Eric,

I have reviewed the revised diving tables which start on Page 41 of 46 and go through Page 46 of 46.

SEPTEMBER 1, 2012 SUPPLEMENT

2010 CALIFORNIA BUILDING CODE

FIGURE 31B-1  
DEPTHS AND CLEARANCES FOR POOLS WITH DIVING BOARDS  
GREATER THAN 30 INCHES (762 mm) ABOVE THE WATER LINE

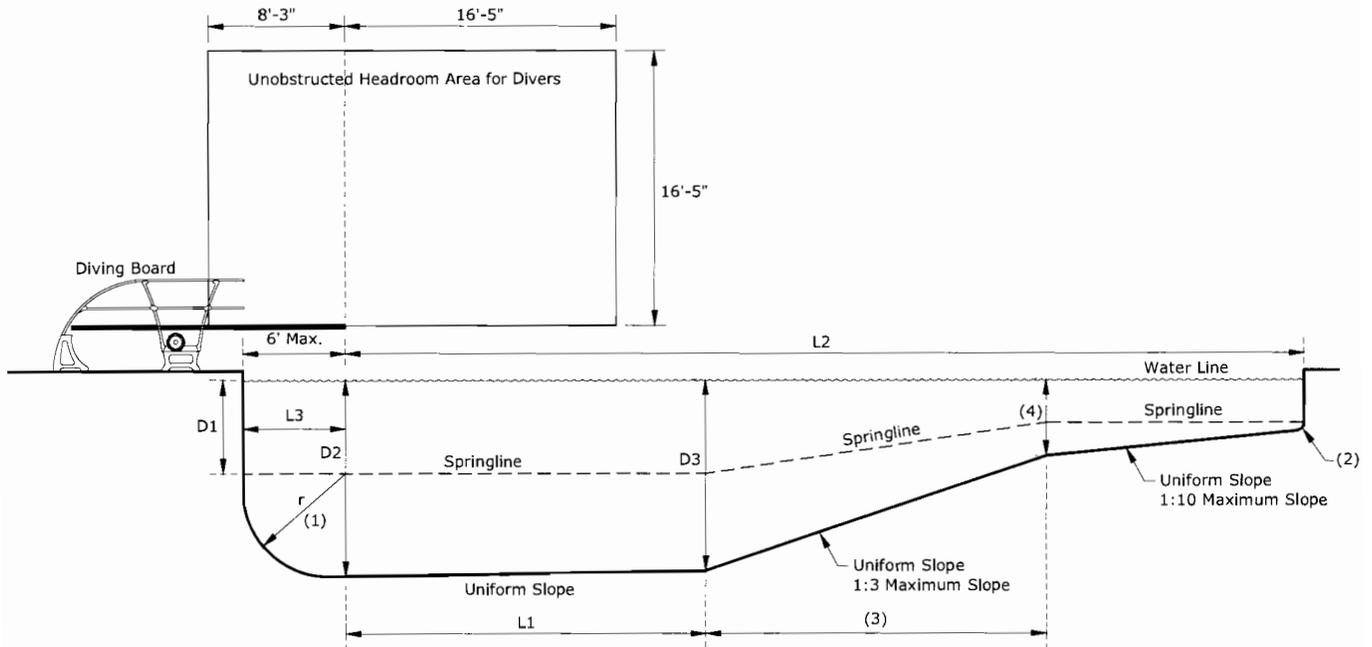
3. What I did on Figure 31B-1 and Table 31B-1 is went through and checked each and every dimension with the U.S. Diving 2010-2011 Handbook (Pages A:4-A:5). All of the dimensions on A:4 and A:5 are in meters; I converted all of the dimensions from meters to feet and inches, so that everything now on the Figure 31B-1 and Table 31B-1 that I am sending you is in feet and inches. The dimensions that were taken from U.S. Diving in each case were not the minimum dimension but the preferred dimension. In converting metric dimensions to feet and inches, I rounded all the dimensions up to the nearest inch in order to be the most conservative.

4. All of the dimensions in Table 31B-1 were correct with the exception of L1 for the 1-meter board and the 3-meter board. The dimension for L1 for a 1-meter board should be 16 feet, 5 inches (16'-5"), and the dimension for L1 for a 3-meter board should be 19 feet, 9 inches (19'-9"). The unobstructed headroom area for divers' dimensions changed slightly when they were converted from metric to feet and inches. Now, the figure and the table I am sending you match or slightly exceed requirements for U.S. Diving, which is the same as the International requirements by the Federation Internationale de Natation (FINA; the international body for all competition diving).

FIGURE 31B-2  
 DEPTHS AND CLEARANCES FOR POOLS WITH DIVING BOARDS  
 30 INCHES (762 mm) OR LESS ABOVE THE WATER LINE

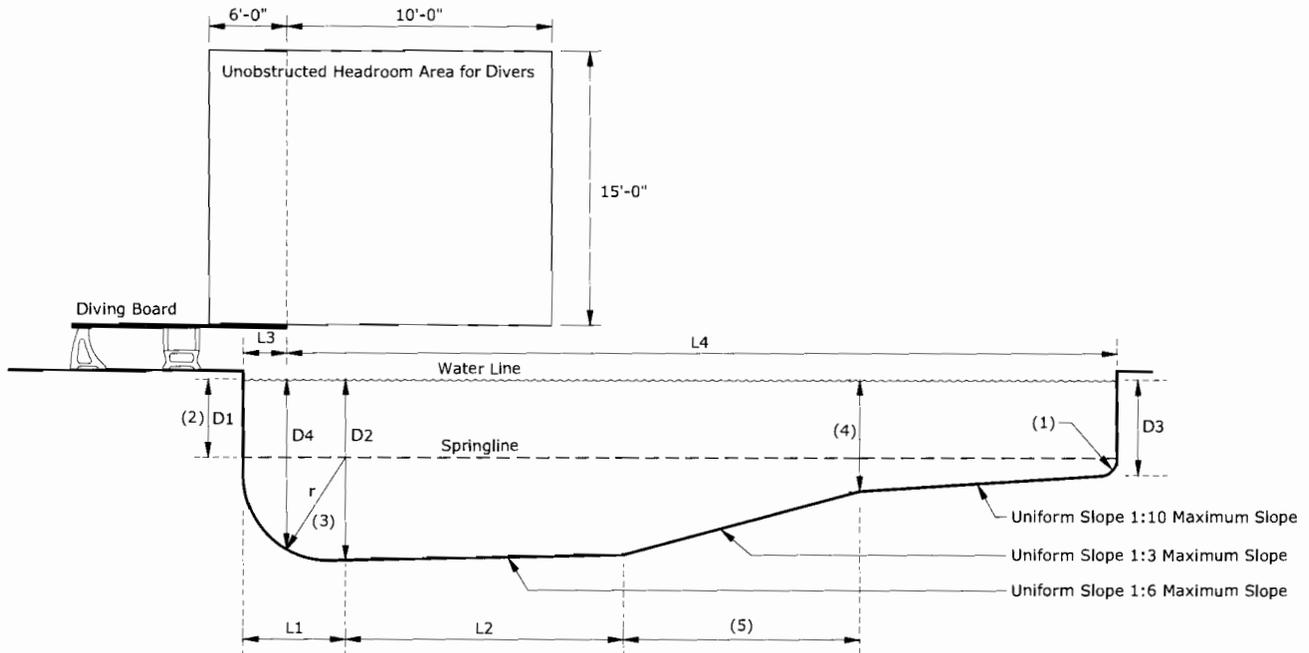
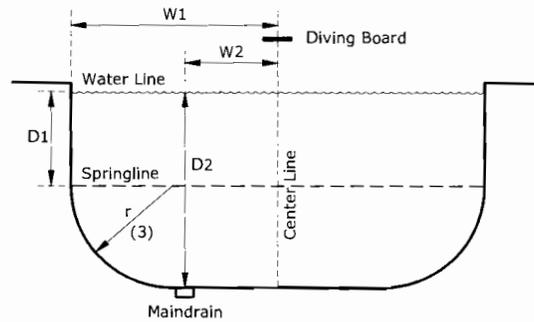
5. I reviewed the Figure 31B-2 and Table 31B-2 and have no input on this in that this is not a springboard whose height is sanctioned by FINA.
6. On Figure 31B-3, and Table 31B-3A and Table 31B-3B, my only comment is: on Table 31B-3A the W1 is 6 feet, which is halfway across the pool, which would make the pool width 12 feet. I (and I know that Los Angeles County Inspector Bernard Franklin) feel that this minimum should be, not 12 feet, but 15 feet in case someone inadvertently dives across the

FIGURE 31B-3  
DEPTHS AND CLEARANCES FOR POOLS WITHOUT DIVING BOARDS

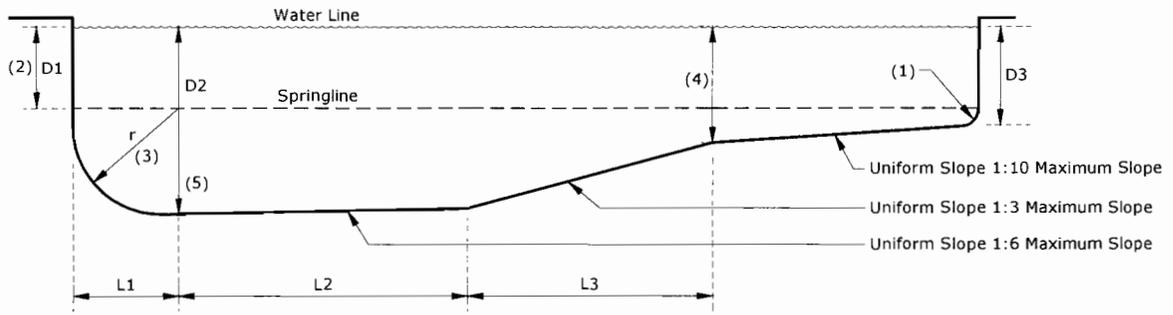
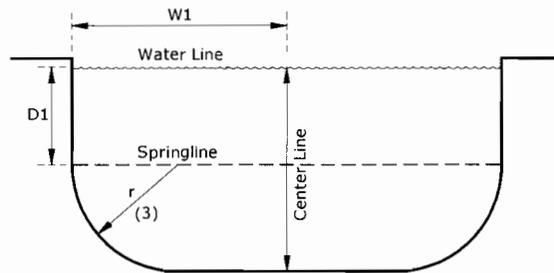
swimming pool. This would give them a greater distance to slow down before they strike their head. For diving safety, I highly recommend increasing this minimum to 15 feet.
